WESTWOOD PLANNING COMMISSION

WE-2024-04 – Application of Christopher Castrop, on behalf of Rick and Helen Ackmann, for a waiver/exception from Westwood Zoning Ordinance: (1) Article 4.3.2.(C) to allow lot coverage in excess of that allowable, (2) Article No. 4.3.2(D) to allow a primary structure to have less than 60% of its front façade on the front build- to line, (3) Article 4.3.2(J)4.b to allow a front yard setback less than 35’, and (4) Article 4.3.2(J)4.c to allow the maximum lot width coverage at the front yard setback to exceed 70% for a proposed new single-family residence on property located at 2023 W. 48th St., Westwood, Kansas 66205.

Evaluation of Permit Application Conformance with Westwood Zoning Regulations

Review Conducted by: Joe Kmetz (GBA)
Owner of Record: Ackmann
Applicant: CDG
Address: 2023 W. 48th St.
Residential Zoning District: R-1(D)
Description of Proposed Project: New Single Family Residence

PLOT PLAN
 2023 WEST 48TH STREET
 CITY OF WESTWOOD
 JOHNSON COUNTY
 KANSAS

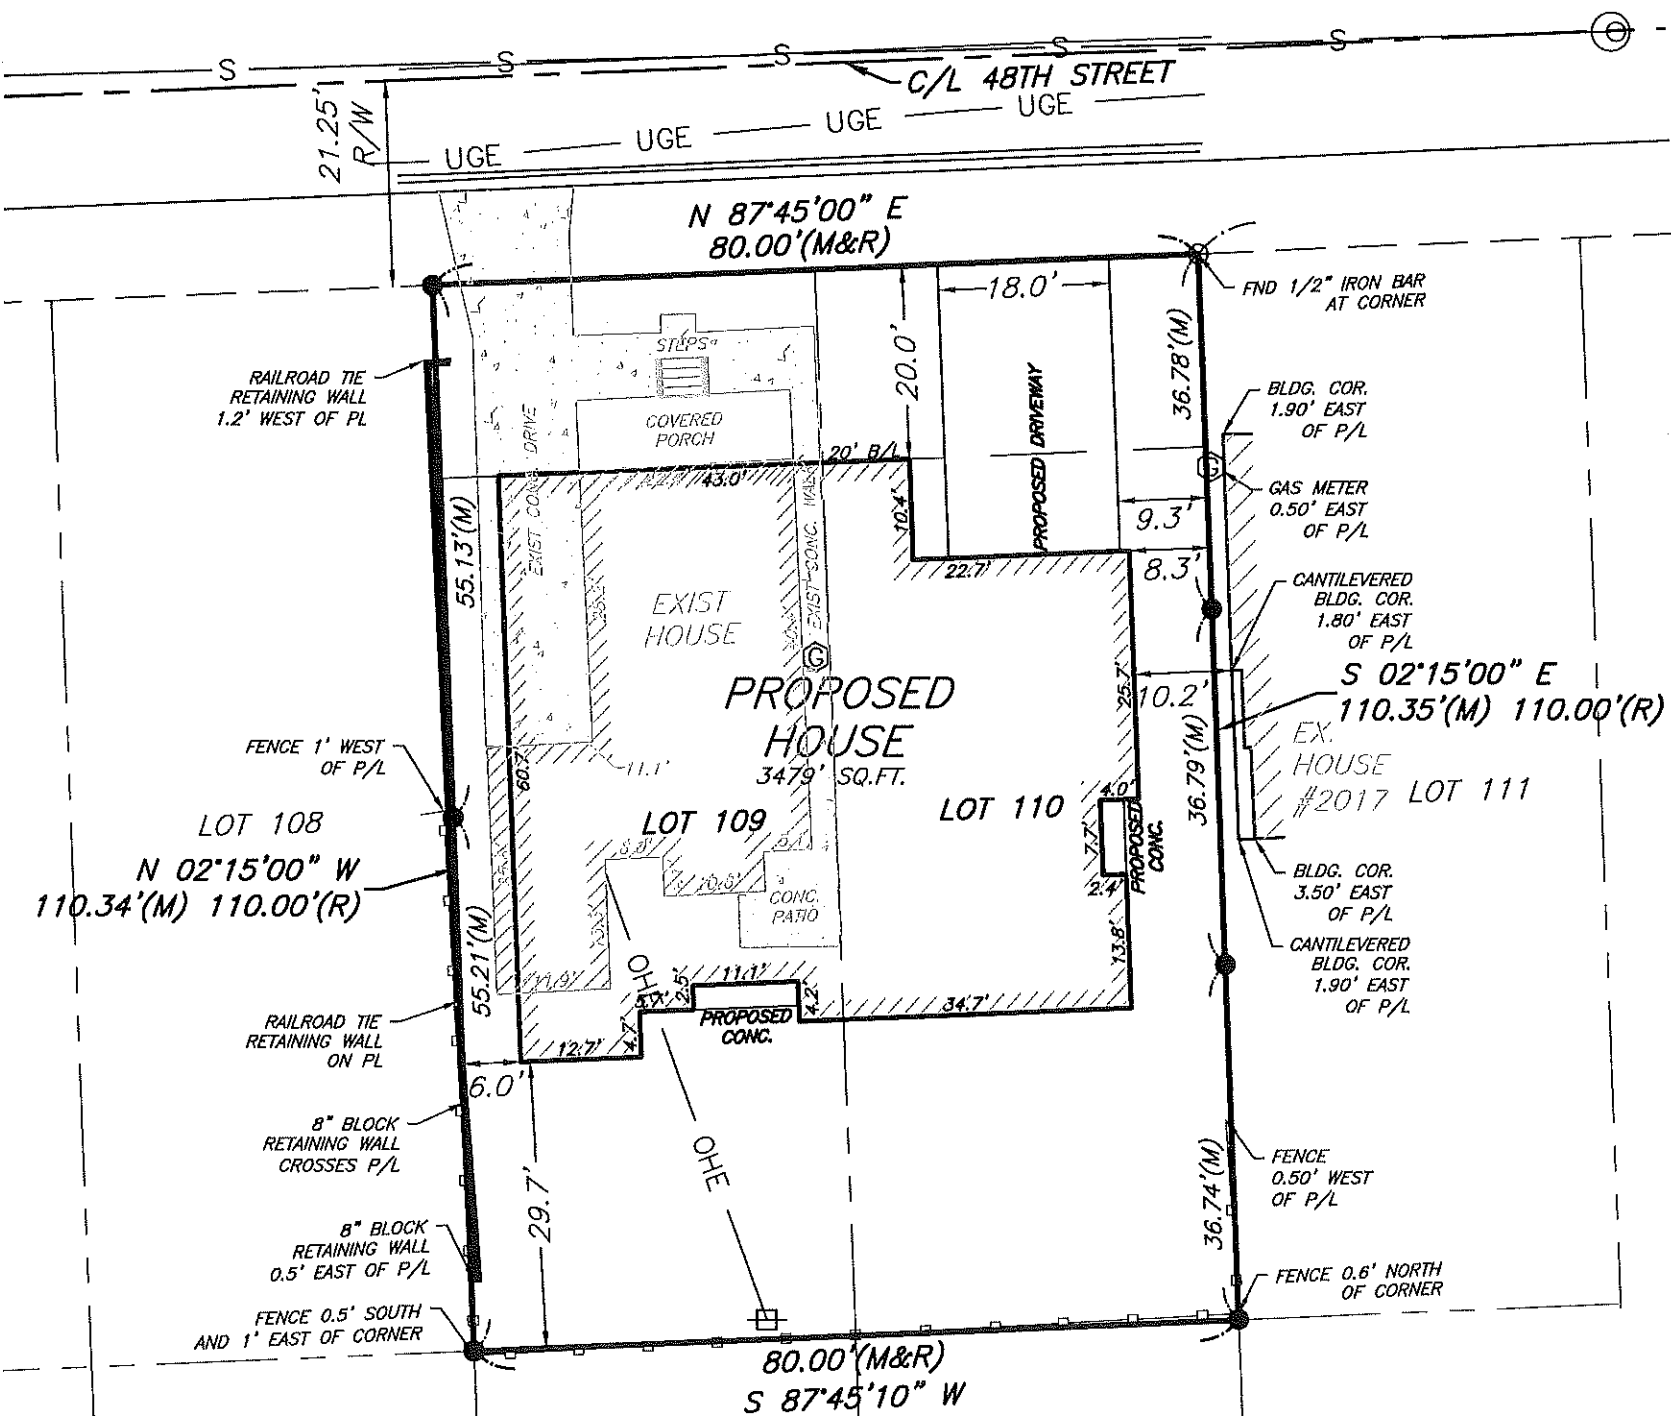
Setback – Front yard (4.3.2.J)	Based on zoning district	No, Req'd: 35' Actual: 28 ft (requires waiver/exception)
Setback – Side yard (1st story) (4.3.2.I)	Based on zoning district	Yes, Req'd: 5'

Actual: 10' & 6'
Setback – Side yard (2nd story) (4.3.2.J)	7'	Yes Actual: 10' & 6'
Setback – Back yard (4.3.2.J)	Based on zoning district	Yes, Req'd: greater of 15' or 20% of depth (22') Actual: 30'
